MIL-M-63320A(AR)
AMENDMENT 4
25 APRIL 1990
SUPERSEDING
AMENDMENT 3
27 March 1989

MILITARY SPECIFICATION

Microcircuit, DIGITAL, CMOS (INITIAL LOGIC)

FIGURE 1. Test Circuit for Leakage Current (Oscillator) and Oscillator Function tests.

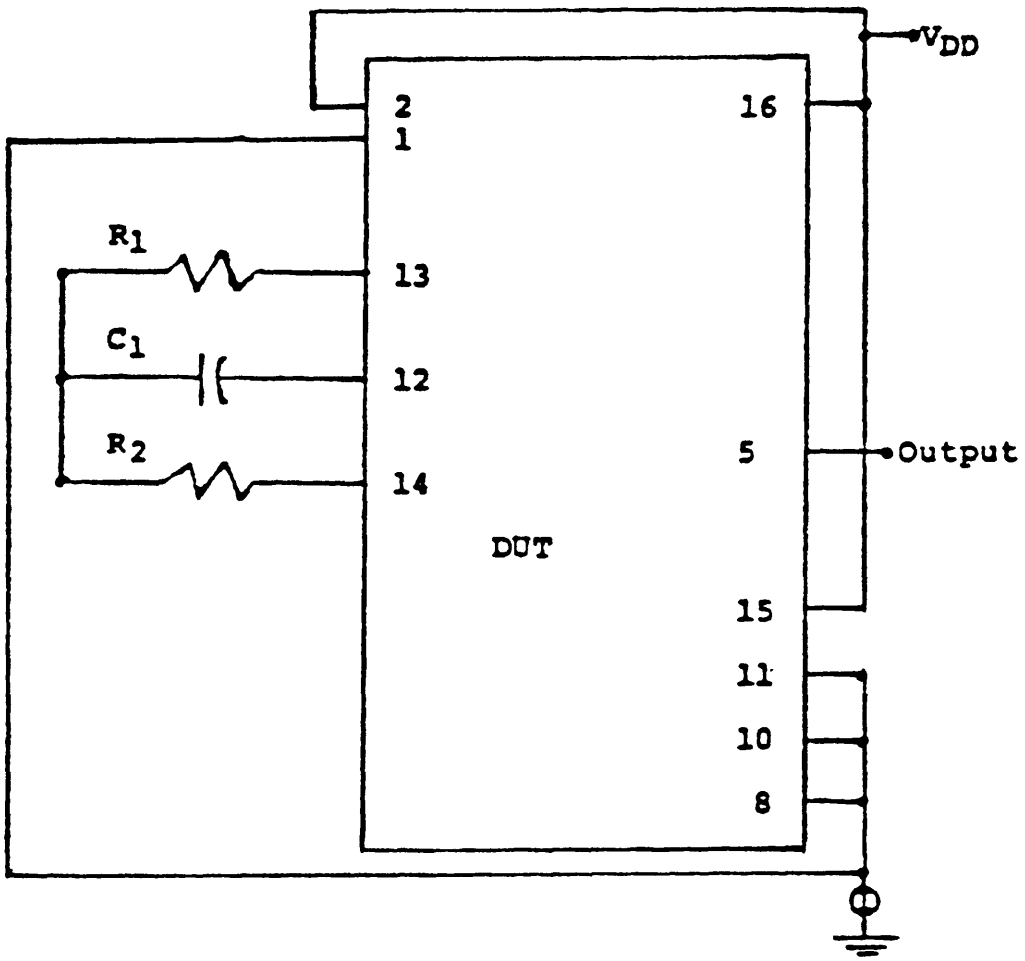
FIGURE 1: Delete present and substitute revised FIGURE 1 included to this amendment.

FIGURE 15. Burn-in and Steady State Life-Test Circuit.

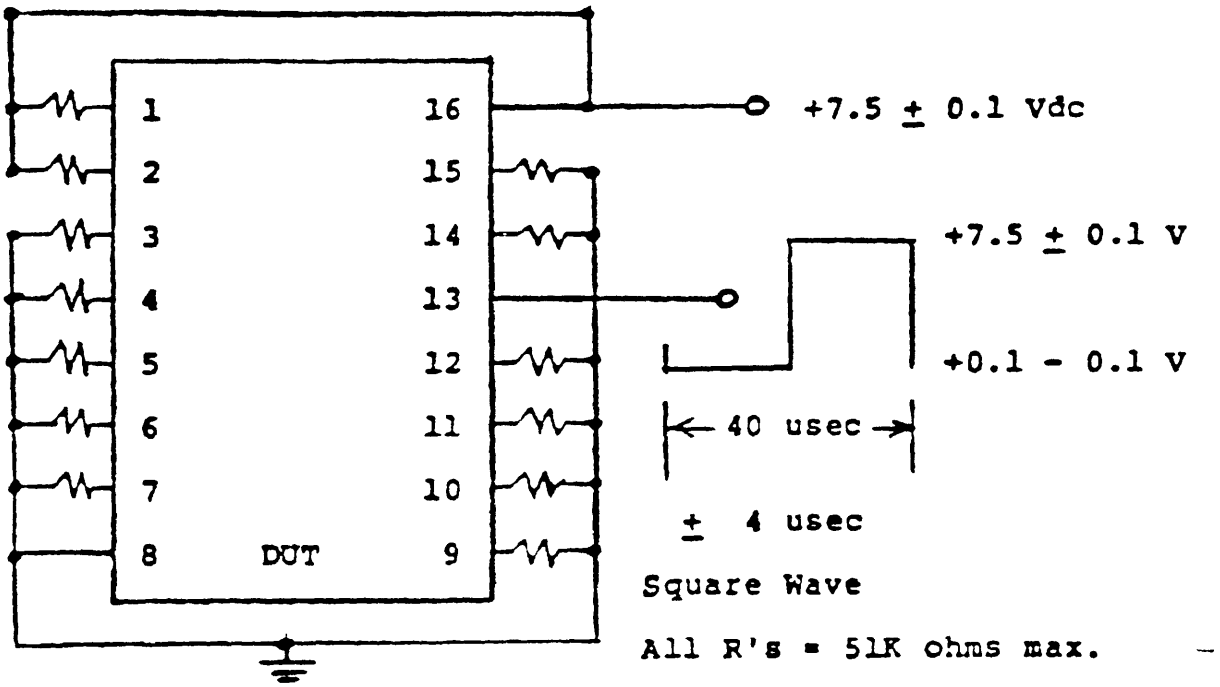
FIGURE 15: Delete present and substitute revised FIGURE 15 includes to this amendment.

FIGURE 15: Delete "7.5 ±0,1 V dc, ± 7.5 ±0,1 V (Square Wave) and substitute '±8.0 ±-0.5 V dc, ± 8.0 ±0.5 V (Square Wave)" .
